# Comment #18

## T-Coil Model for COM

IEEE P802.3bs 400GbE Task Force

May 25-27, 2016 IEEE 802.3 interim meeting

# T-Coil Model [1,2]

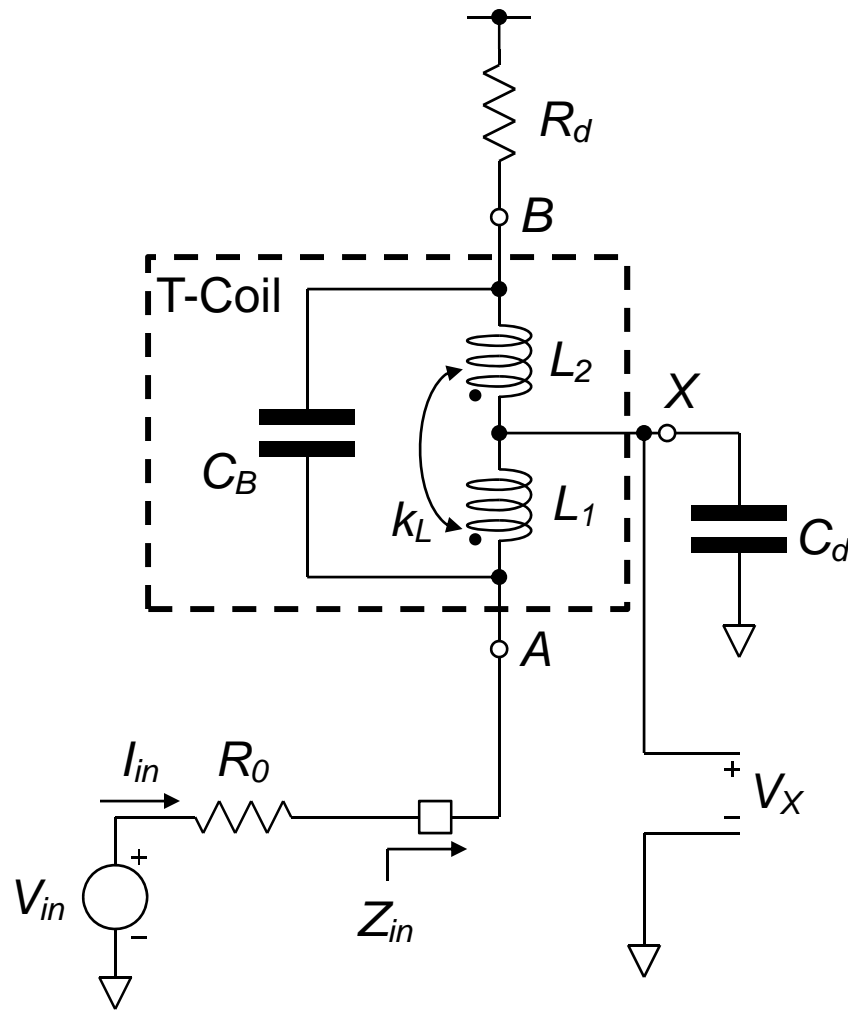
The device capacitance  $C_d$  of 0.28pF causes too much reflection in COM model.

Just a lump capacitor is too simple and does not represent actual device characteristics with T-Coil (Termination Coil) which is commonly used in many actual devices at this high data rate.

Add T-Coil to the COM model.

## Ideal T-Coil Parameters

$Z_{in} = R_0$  at all frequencies, when

$$k_L = \frac{4\zeta^2 - 1}{4\zeta^2 + 1}$$

$$C_B = \frac{C_d}{16\zeta^2}$$

$$L_1 = L_2 = \frac{C_d R_0^2}{4} \left( 1 + \frac{1}{4\zeta^2} \right)$$

$$R_d = R_0$$
